# Access Compliance Report

## Public Rights-of-Way

Intersection ID: 29405	Main Street: GOLD_PAN_RD	Cross Street: REEDY_PLANTATION_RD	Location: SE
ADA ID: 5C945CF77752	Ramp Type: BlendTrans1	Initial Pass/Fail: Pass	Overall Compliance: No
		Severity Score: 0

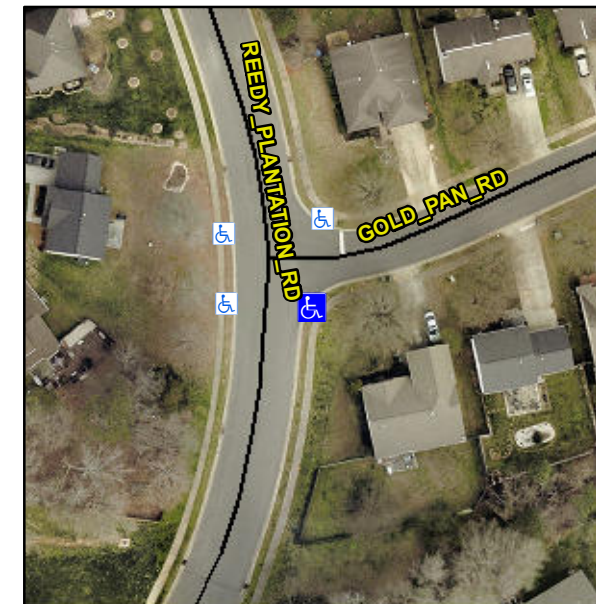
**Not Found, R304.2.1, R305.2**

Compliance	Description	Data	Compliance	Description	Data
N/A	Ramp Length (in)	53.5	Yes	BlendTrans Slope (%)	1.7
Yes	Ramp Width (in)	48.0	Yes	BlendTrans XSlope (%)	2.0
N/A	Flare Type LT	Sloped	N/A	Flare Type RT	Sloped
N/A	Flare Slope LT (%)	3.9	N/A	Flare Slope RT (%)	2.8
N/A	Flare Traversable LT?	No	N/A	Flare Traversable RT?	No
No	Landing Length (in)	46.5	Yes	DWS Provided?	Yes
Yes	Landing Width (in)	48.0	Yes	DWS Contrast?	Yes
Yes	Landing Slope (%)	0.0	Yes	DWS Length (in)	24.0
Yes	Landing X Slope (%)	0.7	Yes	DWS Full Width?	Yes
N/A	Landing Curb? (Y/N)	No	No	DWS Offset (in)	4.0
N/A	Shared Landing?	No			
Yes	Gutter Ponding?	No	Yes	Gutter Slope (%)	2.1
Yes	Gutter Lip Ht (in)	0.0	Yes	Gutter X Slope (%)	0.7
N/A	Painted X Walk1?	No	N/A	Painted X Walk2?	No
	X Walk 1 Direction	To N		X Walk 2 Direction	To W
	X Walk 1 Width (in)	N/A		X Walk 2 Width (in)	N/A
	X Walk 1 Slope (%)	3.6		X Walk 2 Slope (%)	4.0
	X Walk 1 X Slope (%)	2.7		X Walk 2 X Slope (%)	3.9

N/A	Ramp inside XWalk1?	N/A	N/A	Ramp inside XWalk2?	N/A
	Road Slope (%)	1.4		Clear Space?	Yes
	Road X Slope (%)	5.2	N/A	Clear Space to XWalk (in)	N/A
Yes	Any Obstructions?	No	Yes	Storm Grate/Utility Hazard?	No
	Obstruction Type			Storm Grate/Utility Type	
		N/A			N/A
			Yes	Surface Condition? (G/P)	Good
			No	Curb Slope (%)	13.7

**Remove & Replace Curb Ramp With Two New Directional Ramps or Equivalent.**
